dsPIC33EVXXXGM00X/10X Family Silicon Errata and Data Sheet Clarification

The dsPIC33EVXXXGM00X/10X family devices that you have received conform functionally to the current Device Data Sheet (DS70005144H), except for the anomalies described in this document.

The following typographic corrections and clarifications are to be noted for the latest version of the device data sheet (DS70005144H):

FIGURE 1:

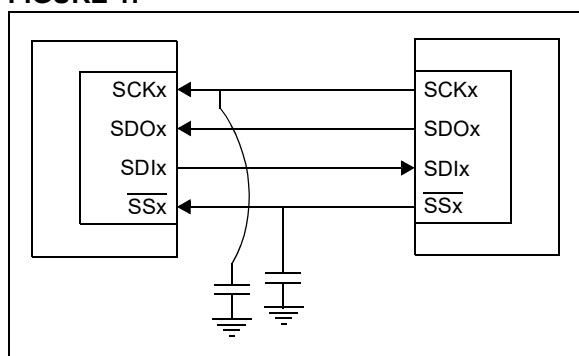
When the SPIx module is configured in SPIx Slave mode (MSTEN bit (SPIxCON1[5]) = 0), the frame slave (FRMEN bit (SPIxCON2[15]) = 1) and the SPIFSD bit (SPIxCON2[14] = 1), in Standard Buffer mode with the Clock Polarity Select bit, CKP = 0, the data are not transmitted in both 8-bit and 16-bit mode, but the data are being received correctly.

Adding a capacitance on the signal, as shown in Figure 1, will help the data to be received properly.

FIGURE 2: TIMING DIAGRAMS FOR CENTER-ALIGNED AND EDGE-ALIGNED MODES

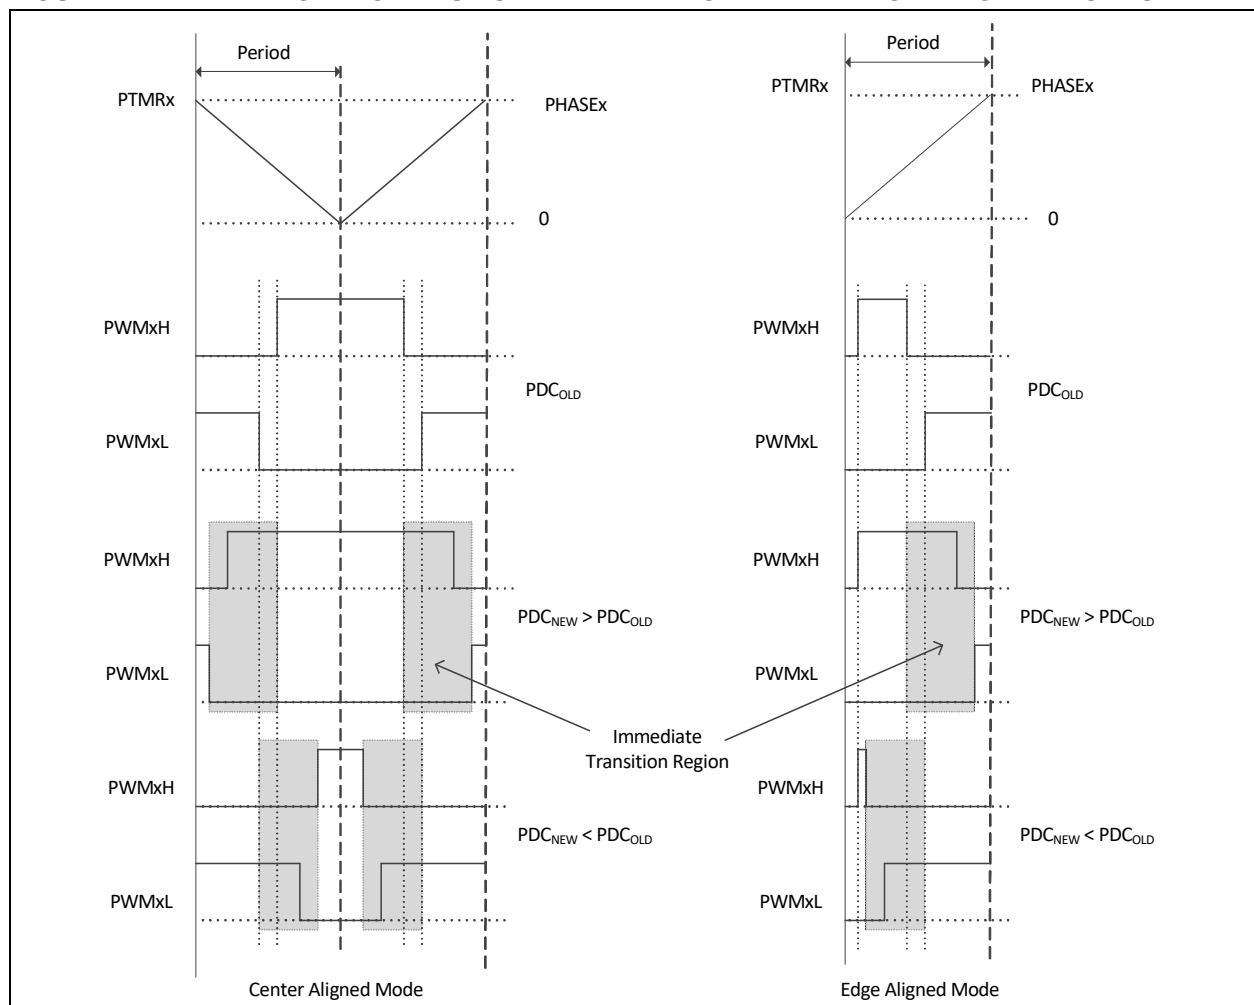
The PWM generator may not assert dead time on the edges of transitions. This has been observed when all of the following conditions are present:

In [Figure 2](#), if the duty cycle write occurred in the shaded box, then PWMxH and PWMxL will make an immediate transition without dead time.

However, in most applications, the duty cycle update timing can be controlled using the TRIGx trigger or Special Event Trigger, such that the above mentioned conditions are avoided altogether.

FIGURE 3: ILLUSTRATION OF 1 TOSC GLITCH WHEN PWM OVERRIDE IS TURNED OFF

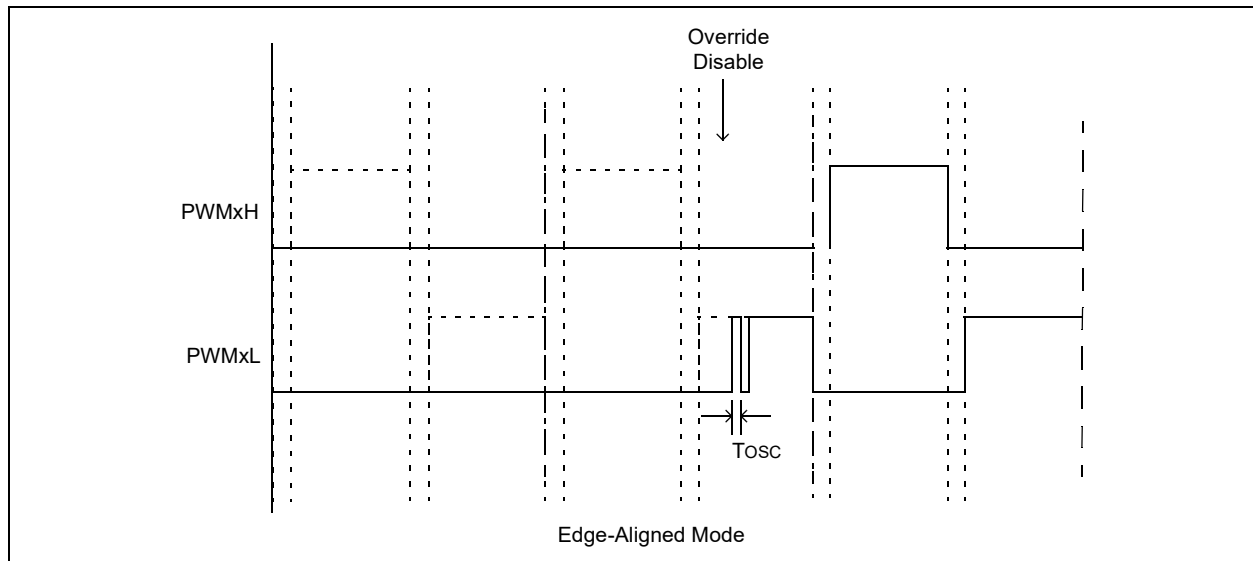
In Complementary mode after the PWM module is enabled ($PTEN = 1$), if the PWM override is turned off, a one TOSC glitch will be present on the rising edge of either the PWMxH or PWMxL pins, whichever occurs first, as shown in Figure 3.

The glitch will be present on PWMxH/PWMxL every time the override state is changed from override enabled to override disabled. The width of this glitch is equal to one TOSC when $PCLKDIV[2:0]$ ($PTCON2[2:0]$) = 000. Increasing the PWMx input clock prescaler setting will increase the width of the glitch accordingly.

FIGURE 4:

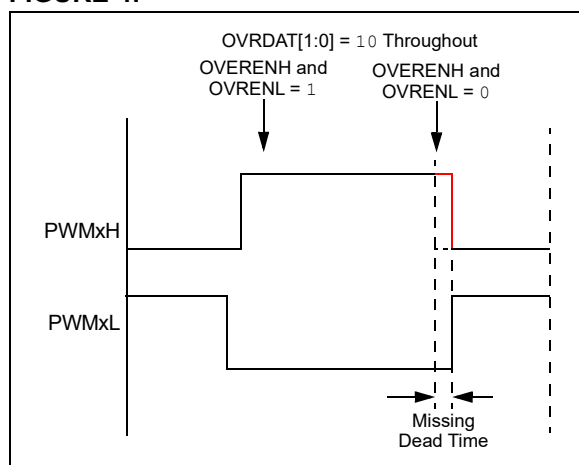
In Complementary Output mode, the expected dead time between transitions of the PWMxH and PWMxL outputs may not be asserted when the following occurs:

- Output override synchronization is configured to occur on the CPU clock boundary (IOCONx[0] = 0);
- Both PWMxH and PWMxL overrides are enabled prior to the event (OVRENH and OVRENL are both '1'), and
- Both overrides are disabled (OVRENH and OVRENL are both '0') at the instant the dead time should be asserted (Figure 4). This has been observed in both Center-Aligned and Edge-Aligned modes.

FIGURE 5:

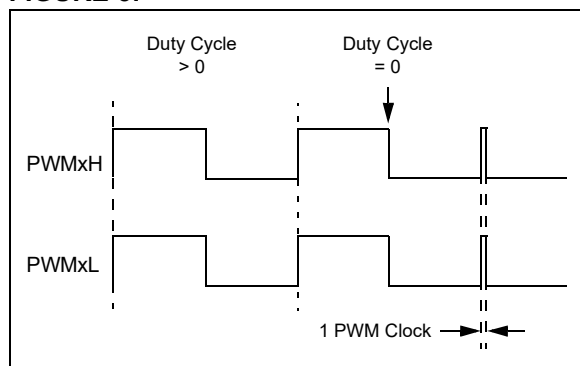
In the Redundant Output mode (IOCONx[11:10] = 10) and Push-Pull Output mode (IOCONx[11:10] = 01) with Immediate Update disabled (PWMCONx[0] = 0), when the Duty Cycle register is updated from a non-zero value to zero, a glitch pulse of a width equal to one PWM clock will appear at the next PWM period boundary, as shown in Figure 5, for the Redundant Output mode. Here, the Duty Cycle register refers to the PDCx register if PWMCONx[8] = 0 or the MDC register if PWMCONx[8] = 1.

If the application requires a zero duty cycle output, there are two possible work around methods:

1. Use the PWM override feature to override the PWM output to a low state instead of writing to the Duty Cycle register. In order to switch back to a non-zero duty cycle output, turn off the PWM override. The override-on and override-off events must be timed close to the PWM period boundary if the IOCONx register has been configured with IOCON[0] = 0 (i.e., output overrides via the OVDDAT[1:0] bits occur on the next CPU clock boundary).

2. Enable the Immediate Update (PWMCONx[0] = 1) while configuring the PWM module, i.e., before enabling the PWM module (PTCON[15] = 1). With Immediate Update enabled, writes to the Duty Cycle register can have an immediate effect on the PWM output. Hence, duty cycle write operations must be timed close to the PWM period boundary in order to avoid distortions in the PWM output.

FIGURE 7: SIMPLIFIED BEHAVIOR

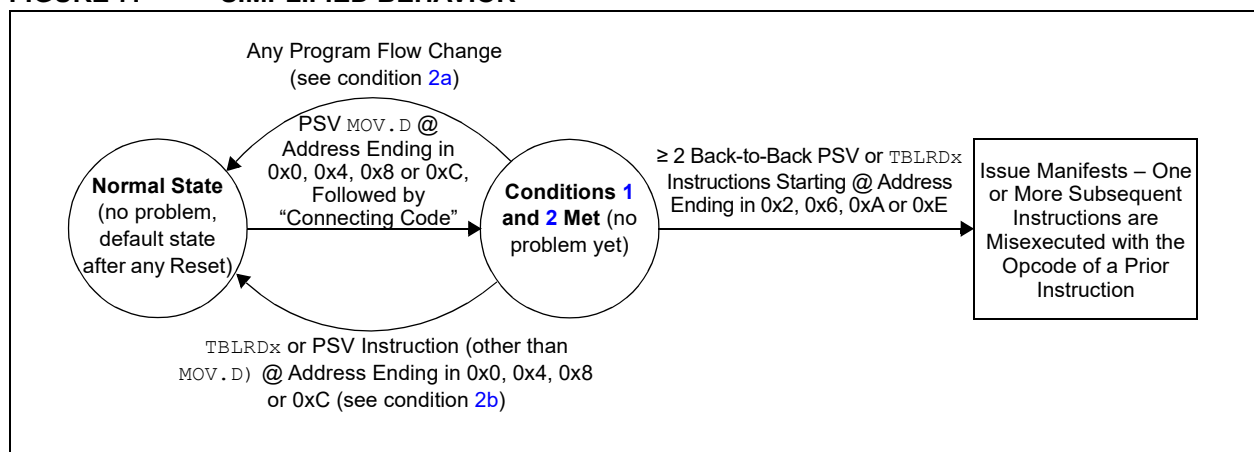
3.	≥ 2 back-to-back PSV or <code>TBLRDx</code> instructions are executed (following the code of condition 2), where the first of the back-to-back instructions is located at an address ending in 0x2, 0x6, 0xA or 0xE.

[Figure 7](#) provides an example of the effective behavior.

1. All instances of PSV MOV.D can be replaced with two PSV MOV instructions instead. Non-PSV MOV.D instructions acting on RAM/SFRs do not need to be modified; or
2. If not already present, a program flow change instruction (such as BRA \$+2) can be inserted above back-to-back data Flash read sequences; or
3. Back-to-back data Flash read instruction sequences can be broken up by inserting a non-Flash read instruction (such as a NOP), in between the Flash read instructions; or
4. The alignment of the code can be shifted to avoid the required opcode location addresses.

C code built with MPLAB® XC16 Compiler Version 1.32, or later, implements the work around by default. However, if the application uses Assembly language routines, these should be manually modified to implement the work around. Additionally, if precompiled libraries are used, these should be built with XC16 Version 1.32 or later. For additional information, please visit: www.microchip.com/erratum_psrds_psrds

**64-Lead Plastic Quad Flat, No Lead Package (MR) – 9x9x0.9 mm Body
with 5.40 x 5.40 Exposed Pad [QFN]**

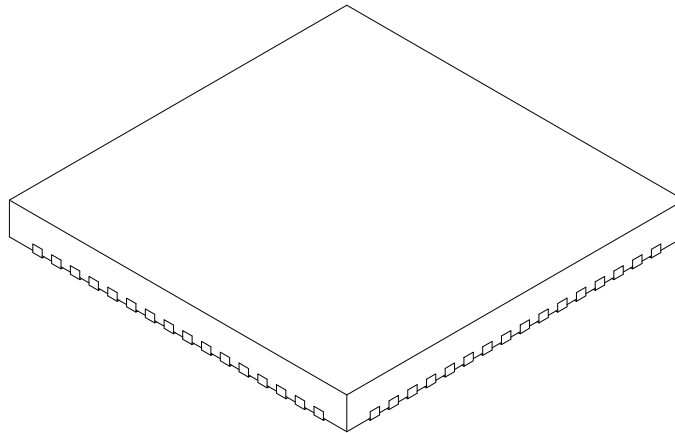
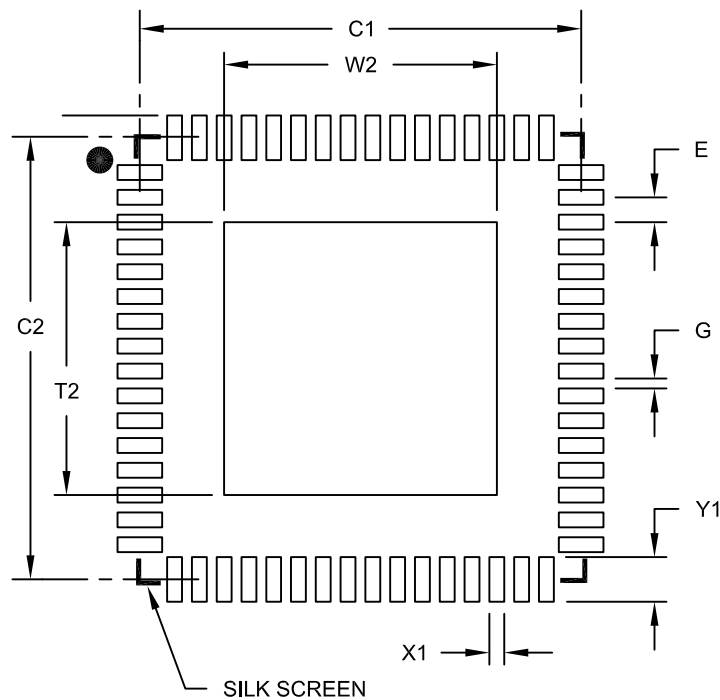
Adds data sheet clarifications 2 ([Interrupt Controller](#)), 3 ([Oscillator Configuration](#)), 4 ([Charge Time Measurement Unit \(CTMU\)](#)) and 5 ([Packaging Information](#)).
